WINSOME FILING NO. 3  
EL PASO COUNTY, COLORADO  
CONSTRUCTION DOCUMENTS  
CROSS SECTIONS

PROJECT NO.  
196106001

WINSOME FILING NO. 3  
 EL PASO COUNTY, COLORADO  
 PRE DEVELOPMENT GESC PLAN  
 GEC FINAL PLAN

13 **FOREBAY DETAIL PLAN VIEW**  
N.T.S.

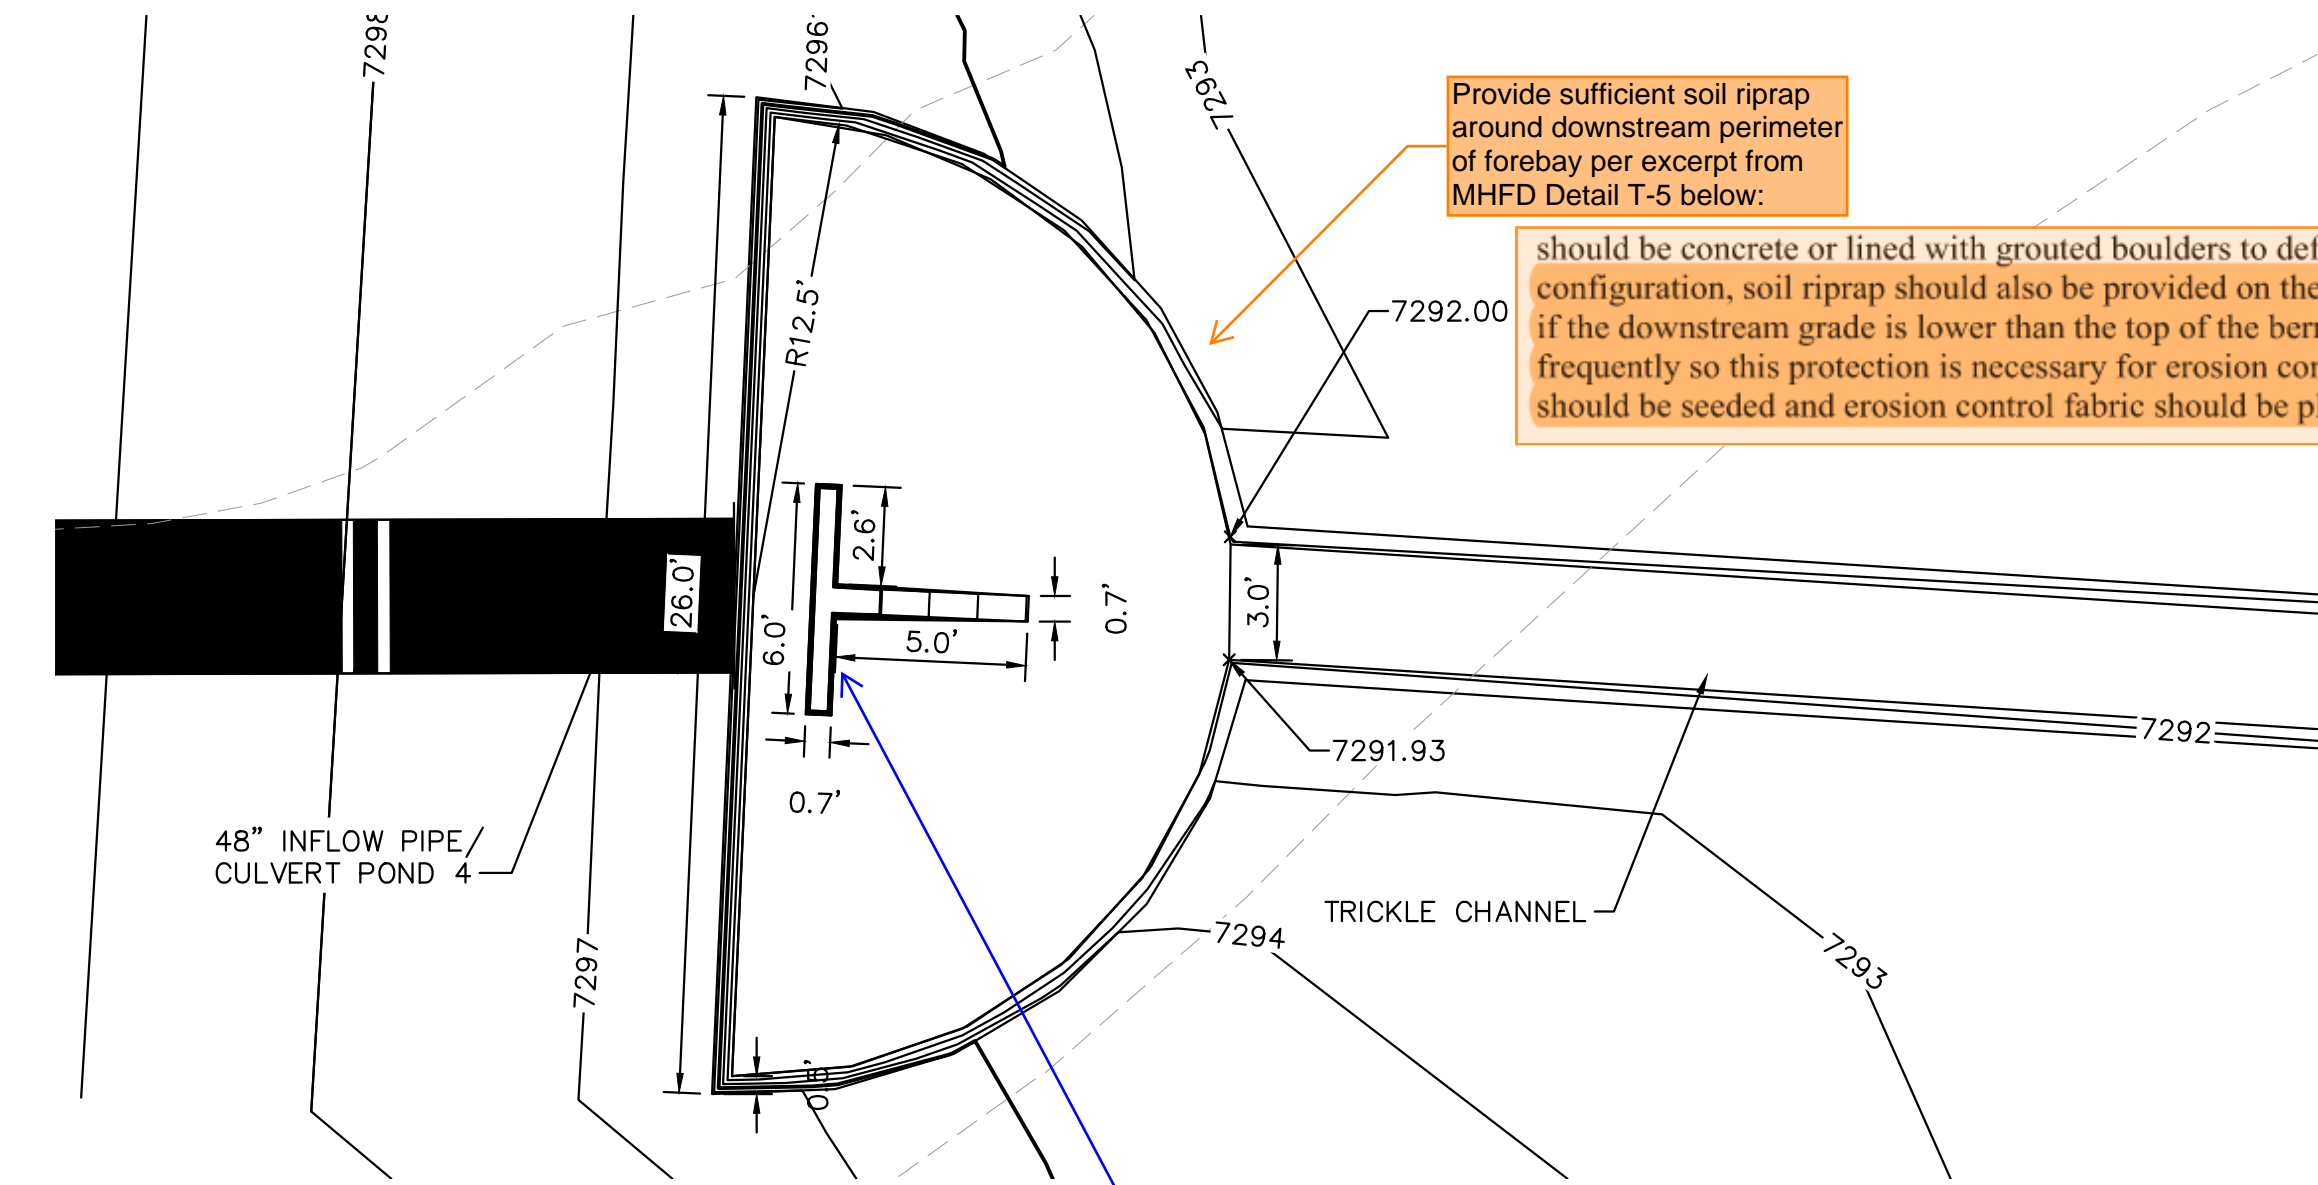
Update and provide additional details. See MHFD DCM Vol 2 chapter 9 for design parameters. See snippet to the left
